STATE OF MAINE
DEPARTMENT OF TRANSPORTATION
16 STATE HOUSE STATION
AUGUSTA, MAINE 04333-0016

February 28, 2023
Subject: Frank J. Wood Bridge Replacement
State WIN: 022603.00
Location: **Brunswick & Topsham**
Amendment No. 2

Filename: ... \106273_44\158A_Lighting_02.DGN

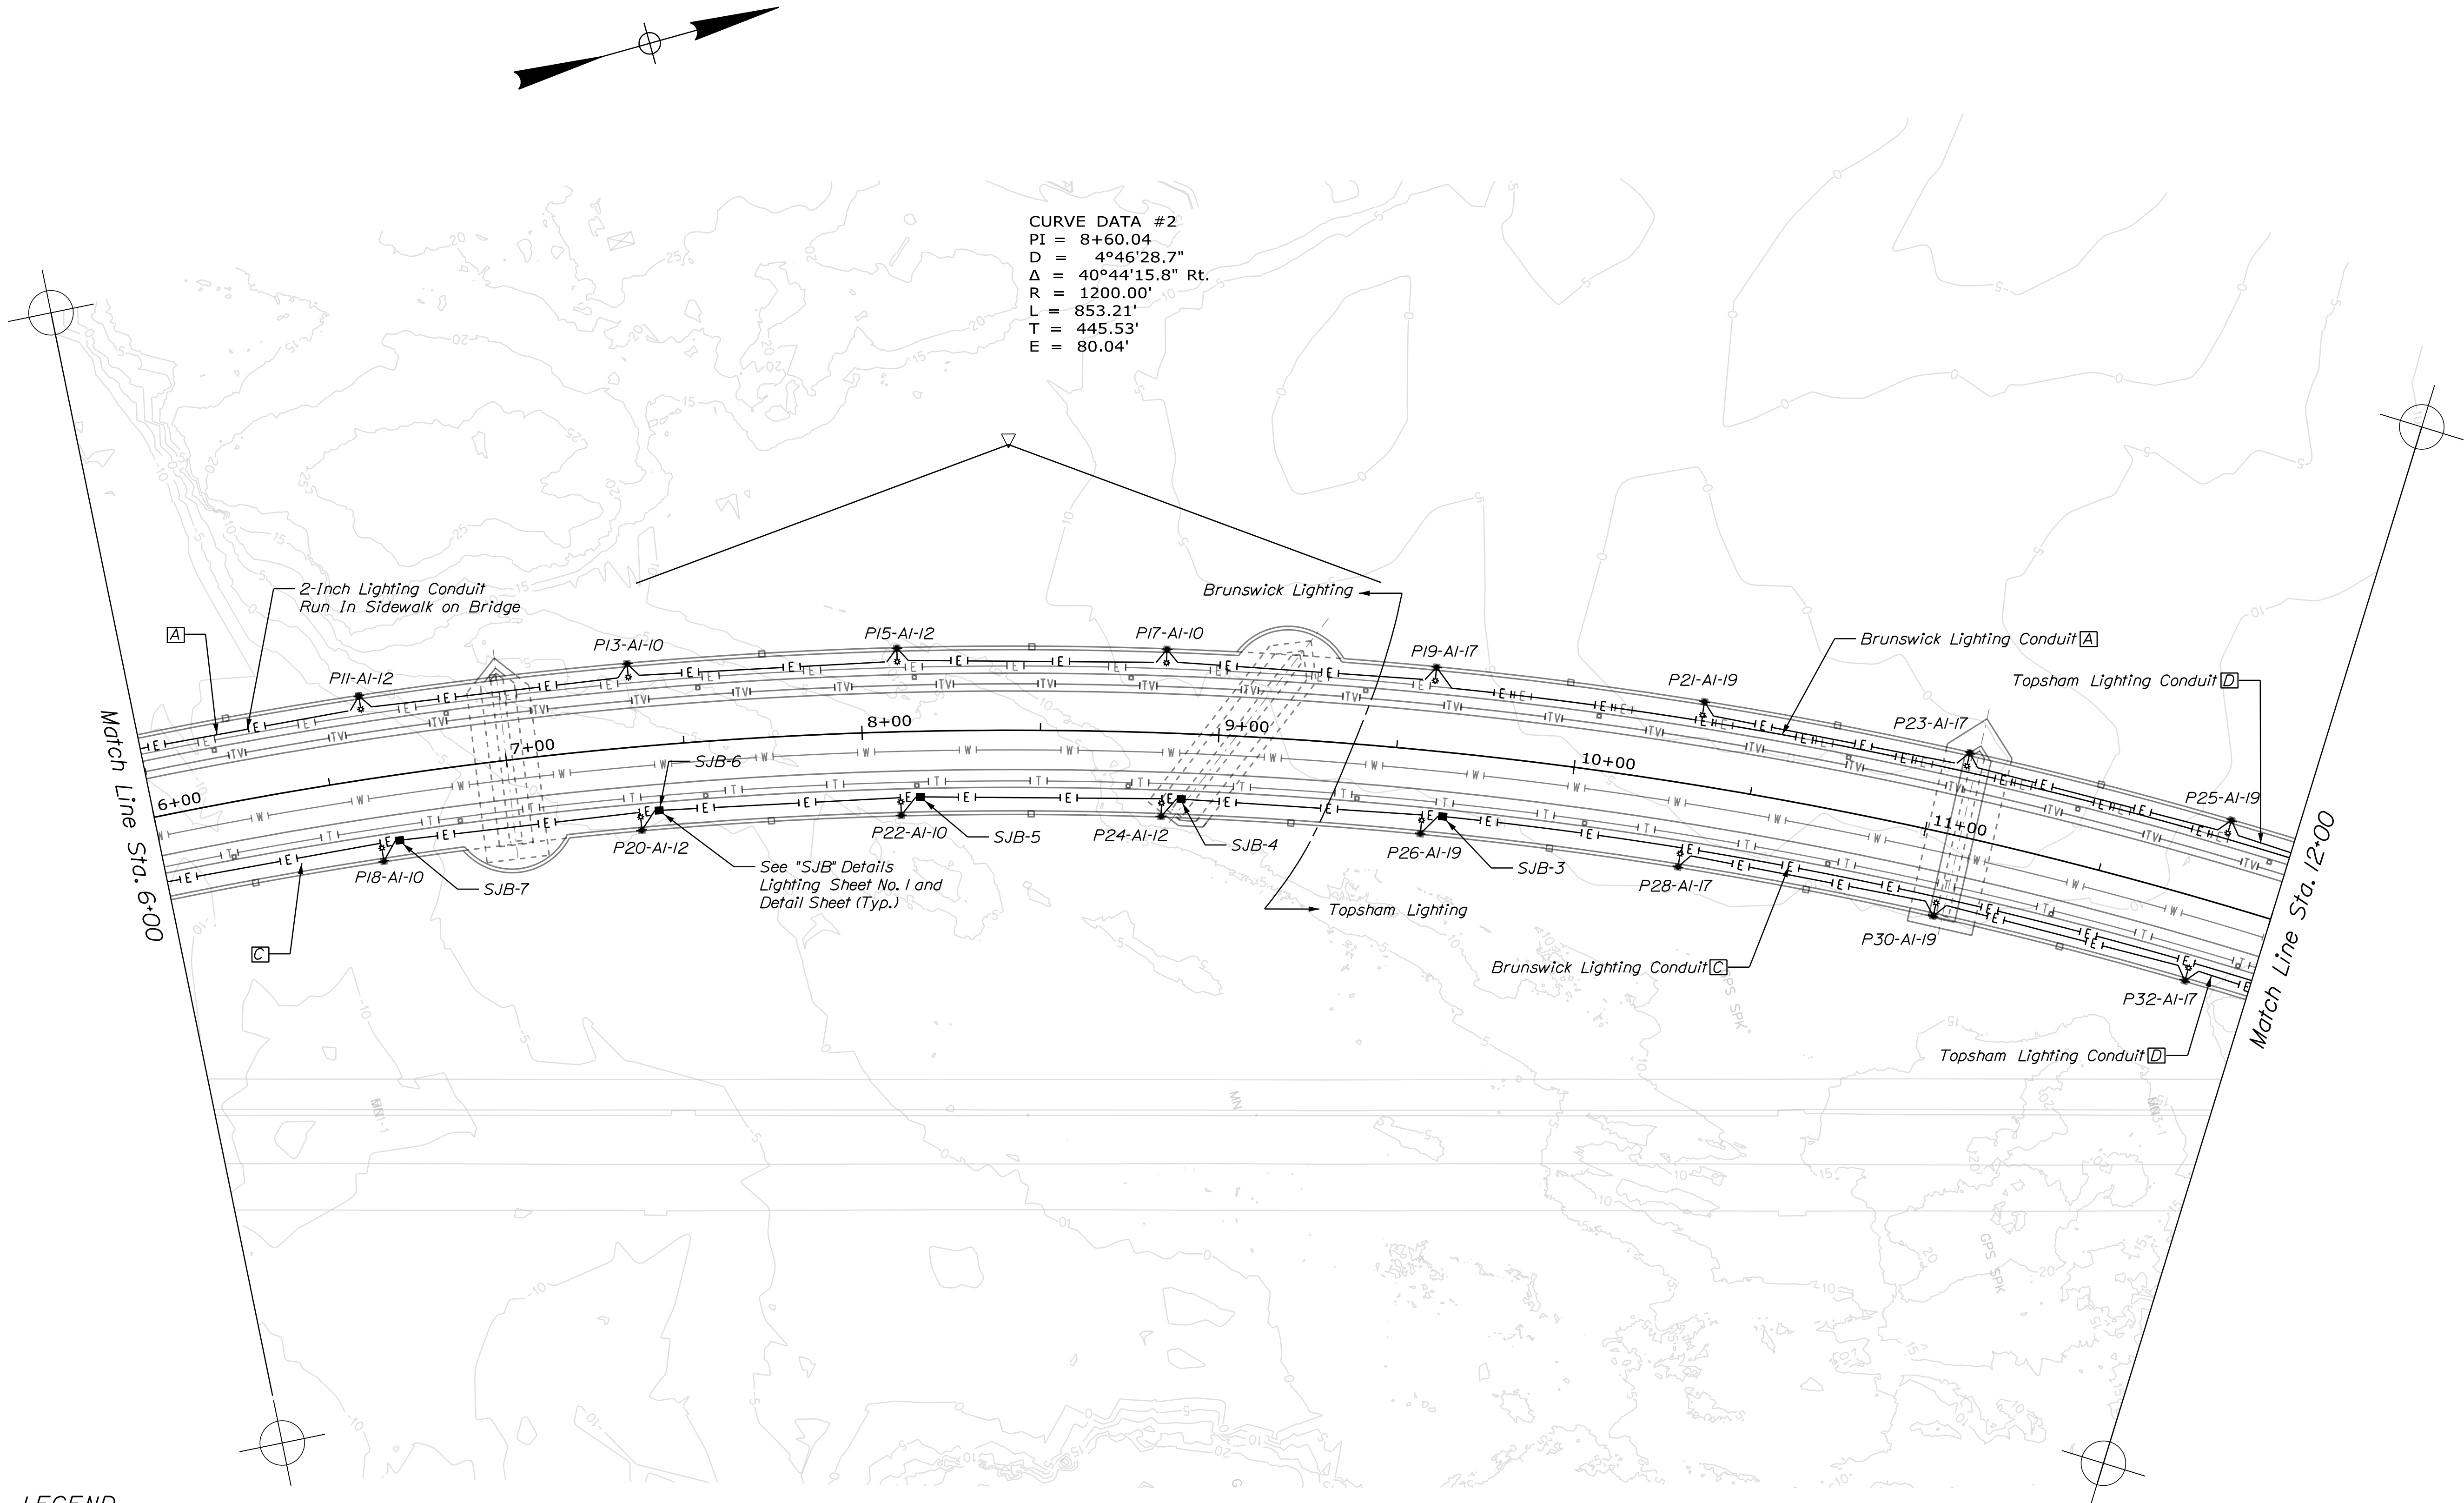
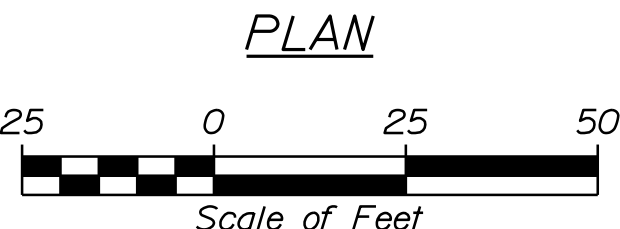
REMOVE sheet 159, LIGHTING PLAN, 1 sheet dated 8/20 and **REPLACE** with attached Sheet 158A, LIGHTING PLAN, 1 sheet dated 2/23.

Question: Could the Lighting Plan Drawings # 157, 158, and 159 be re-issued indicating only the lighting conduits and Circuits. Also indicating which conduits are to be concrete encased?

Response: See above changes to the bid documents.

159A

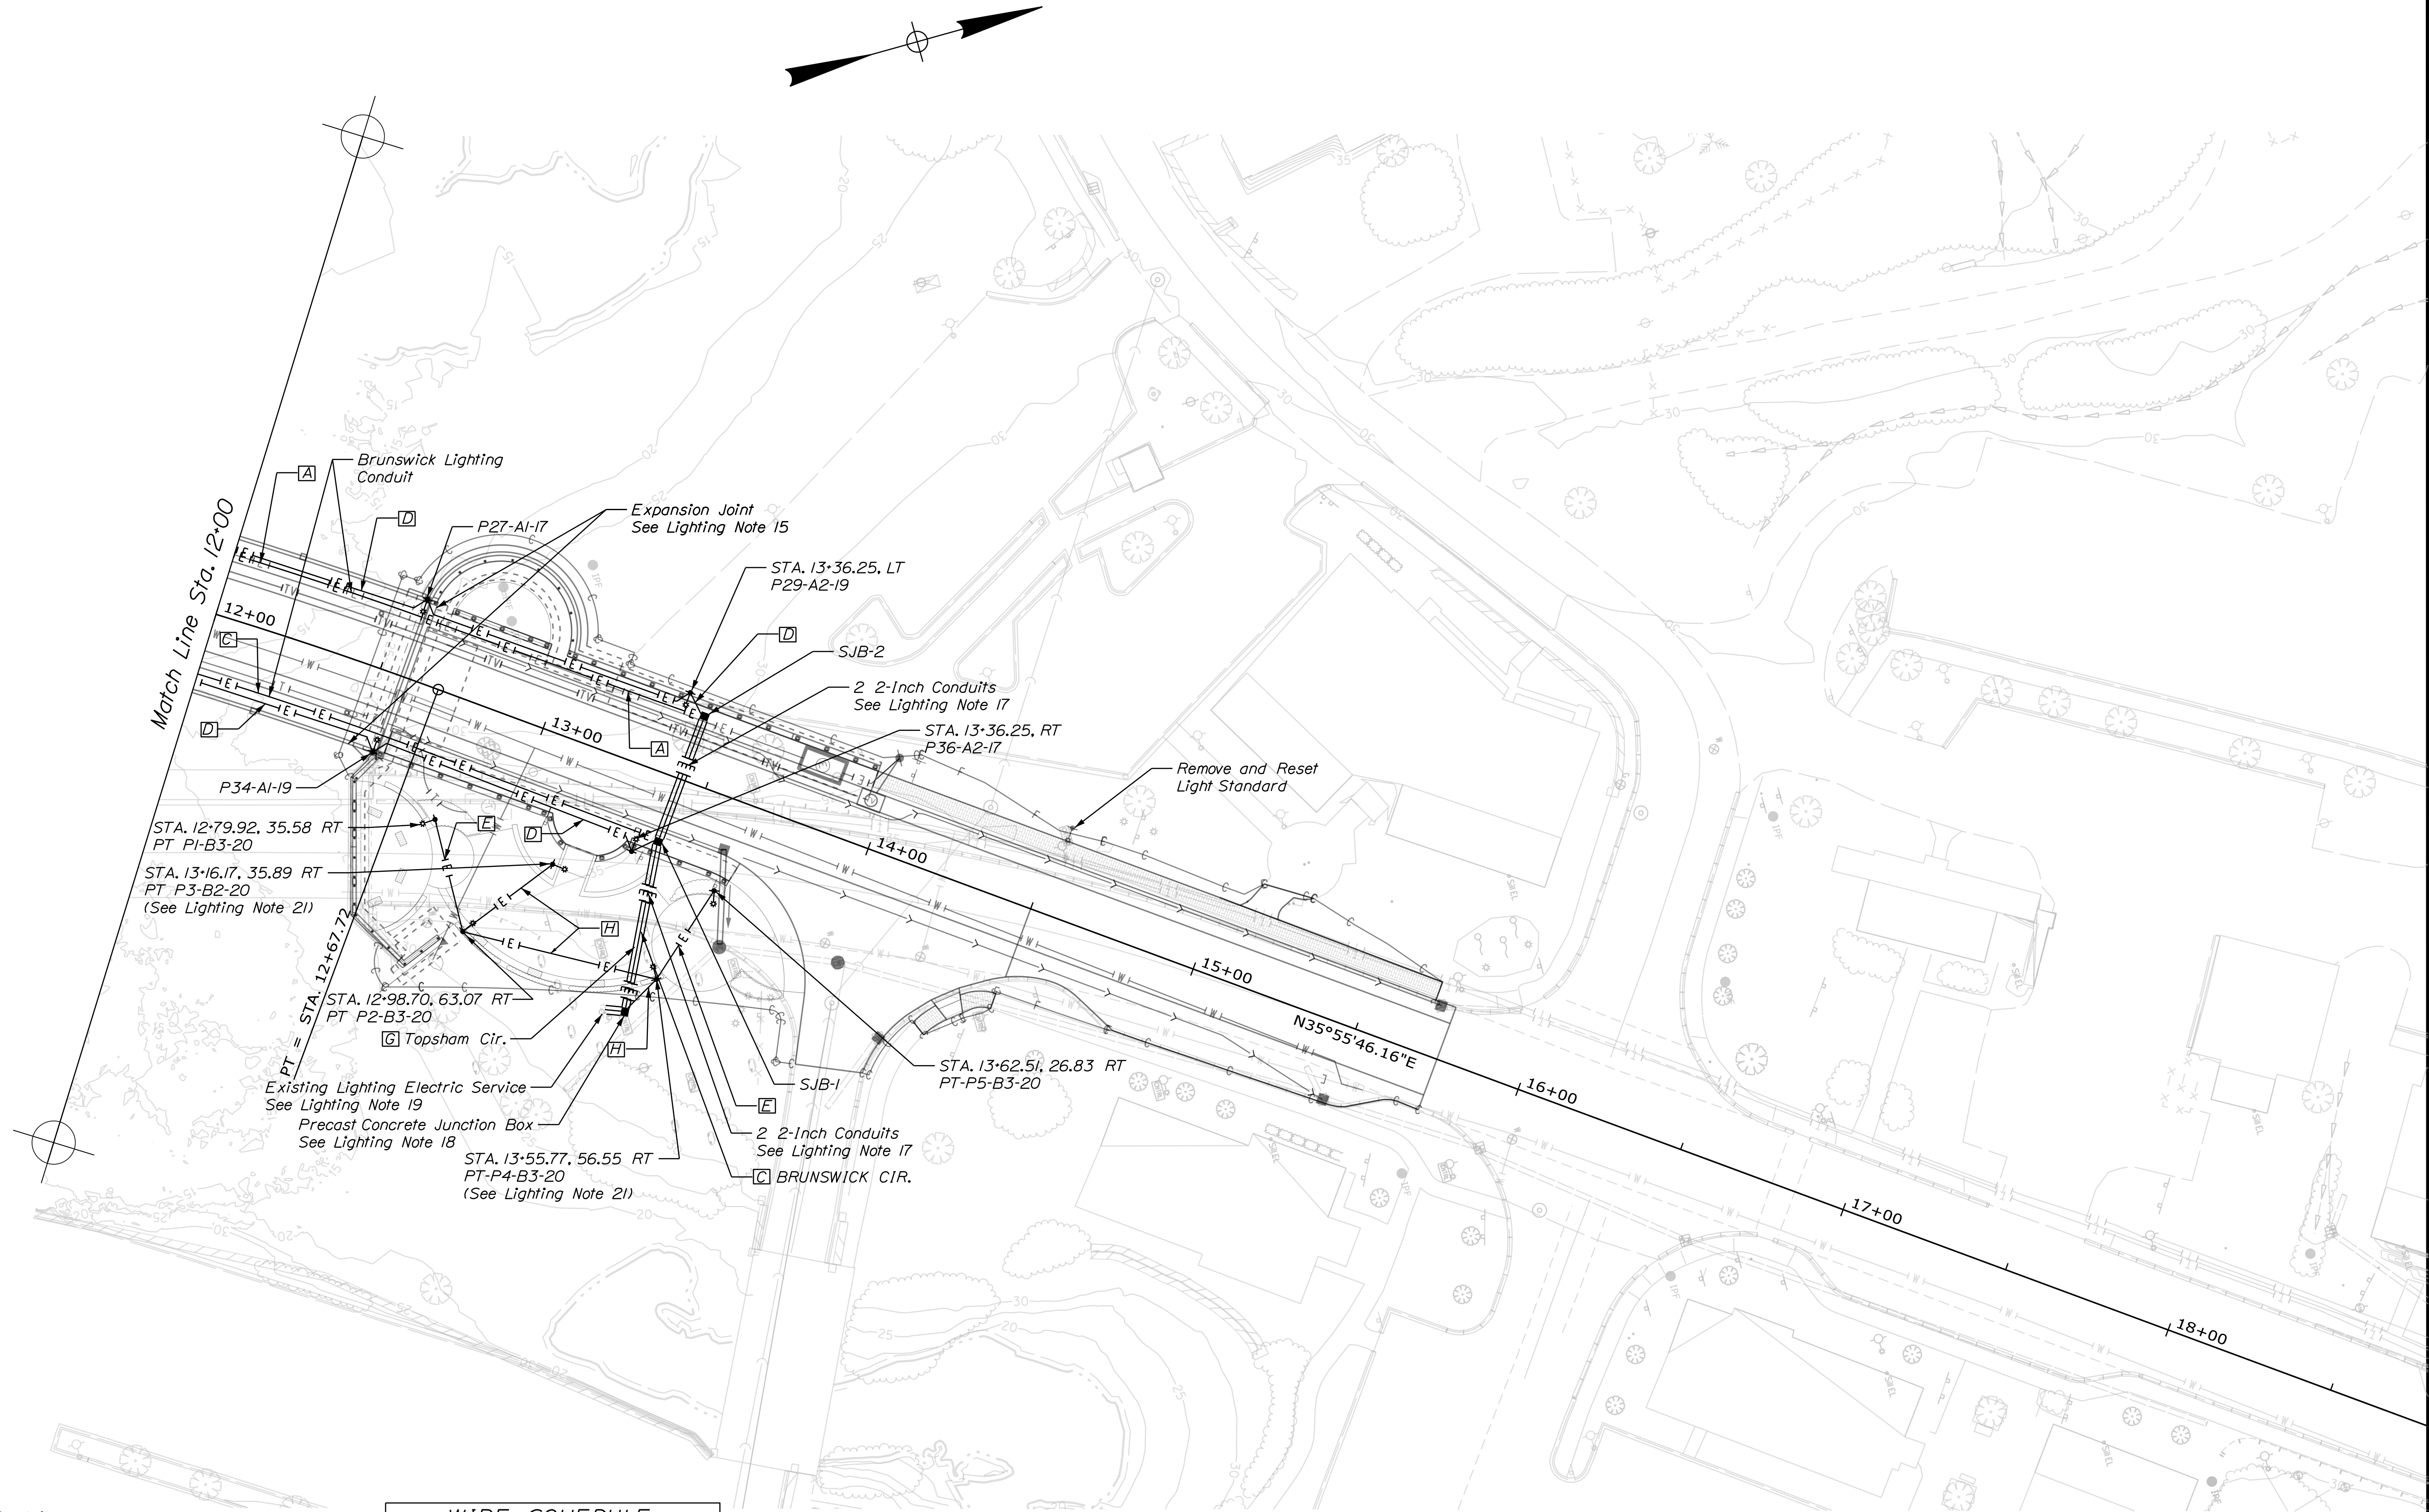
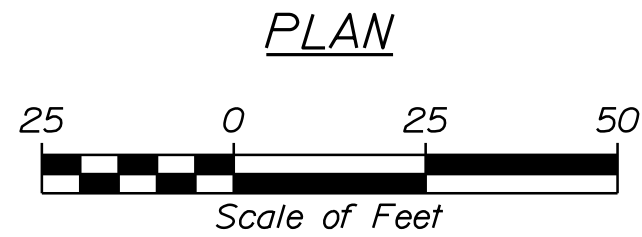
REMOVE sheet 159, LIGHTING PLAN, 1 sheet dated 8/20 and **REPLACE** with attached Sheet 159A, LIGHTING PLAN, 1 sheet dated 2/23.
